The Great Grid Upgrade

Sea Link

Document 9.149 Applicant's Comments on Other Submissions Received at Deadline 6

Planning Inspectorate Reference: EN020026

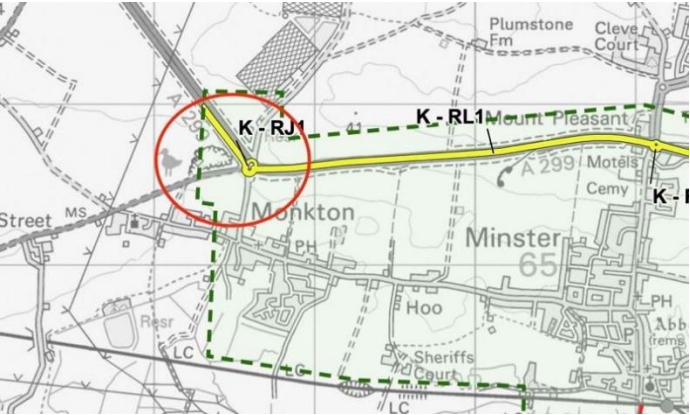
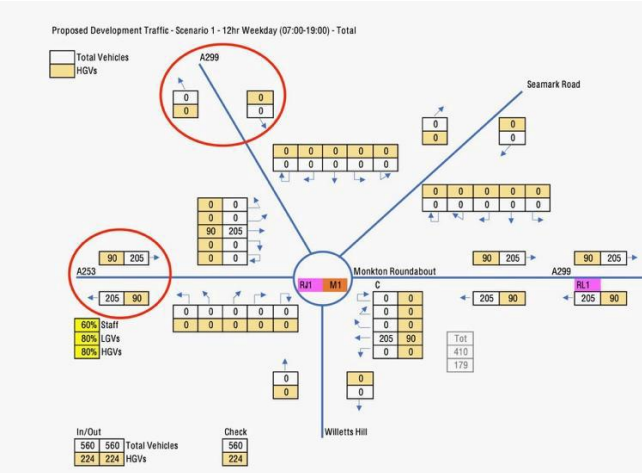
The volume of each column	= $\pi \times r^2 \times \text{depth}$ = 0.6463m ³
Total volume of all columns	= volume of each column x number of columns
	= 0.6463 x 22,500 = 14,542m ³

This is the volume that will be displaced laterally and, since the Tidal Flats are saturated with Sulphate rich water and water does not compress easily, there is a risk of polluting the drainage ditches and the River Stour. It may also pose a flood risk.

The Applicant recognises that over the programme of the project thousands of vehicles will be required for the construction of the project. The Applicant has assessed the maximum number of HGV's accessing the Minster Converter Station site via the main proposed site access on the A256 (access K-BM02) as previously noted in a number of responses to documents submitted by the members of the public and by questions from interested Parties and the ExA. The number of vehicles mentioned by Mr Stevens in the Hearings relates to vehicles importing material to the Minster Converter Site for the creation of the piling platform. The number of these vehicles has been assessed as part of the ES and this has concluded no significant effects.

Figure 1 : Beaver channel to River Stour taken 29 March 2026

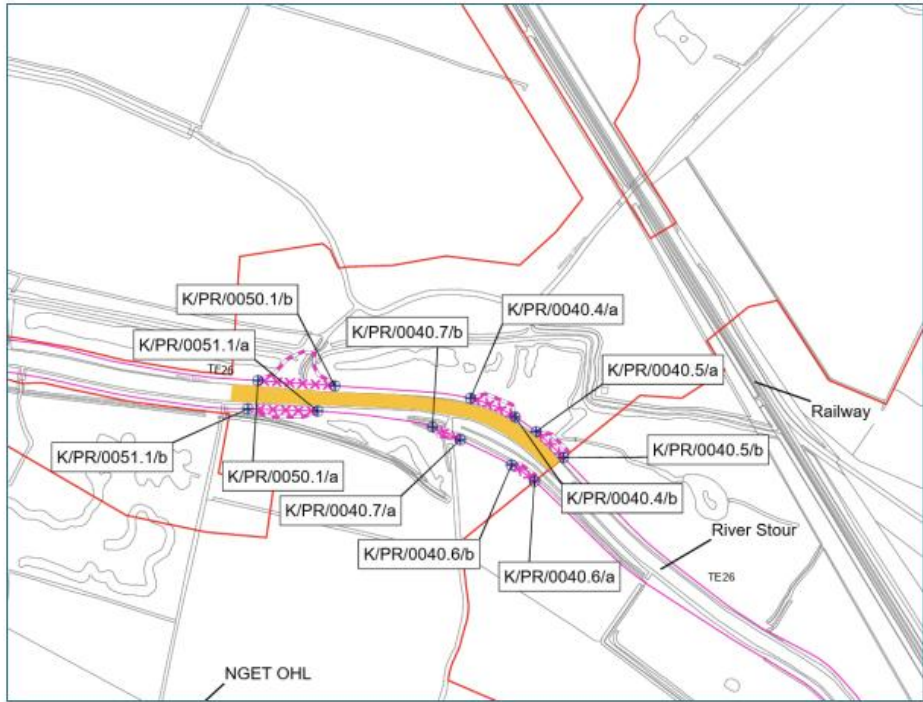
Reference	Matter	Point Raised	Applicant's Comments
	Further submission on behalf of Save Minster Marshes in response to ISH3 question	 This is where George Cooper has identified the probable beaver lodge where the Minster Stream joins the River Stour. George Cooper has a CL52 Beaver licence and as such has had extensive training and experience of beavers. He hopes the project will not force him to have to use his licence for the removal of dead beavers.  It appears from REP4-007 2.5.2. Works Plans Kent page 4 sheet 2 that the entrance to the Minster Stream is marked for special	The Applicant considers the information provided on beaver to be useful supplementary information. The presence of beaver on this section of the River Stour is already known and was established in the Applicant's own surveys reported in 6.3.3.2.H ES Appendix 3.2.H Riparian Mammal Survey Report and 6.4.3.2.H ES Figures Kent Riparian Mammal Report. The location identified is close to the temporary bridge over the River Stour which is required for the overhead line works. While the temporary bridge over the River Stour will not directly interact with the river (since the abutments will be 8m back from the bank top) it is possible that construction of the bridge could lead to disturbance of any lodge in this location if it is present at time of installation. However, the bridge is unlikely to be installed before 2028 and as noted at ISH3, beaver (and other riparian mammal) distribution changes over time. Because of this, the Kent oLEMP submitted at D6 notes that <i>'beaver and otter may adjust their distribution, and this will be picked up during update riparian mammal surveys prior to and during construction'</i>. This is reflected in the survey schedule in Appendix B of the Kent oLEMP. In the event that, as the construction of the temporary bridge over the River Stour approaches, a beaver lodge is confirmed to be present in this area, then either the temporary bridge abutments or alignment will be moved within the order limits to a non-disturbing distance if possible, or an A12 licence will be obtained from Natural England to facilitate the dismantling of any lodge, and suitable mitigation provided in accordance with the licence conditions.
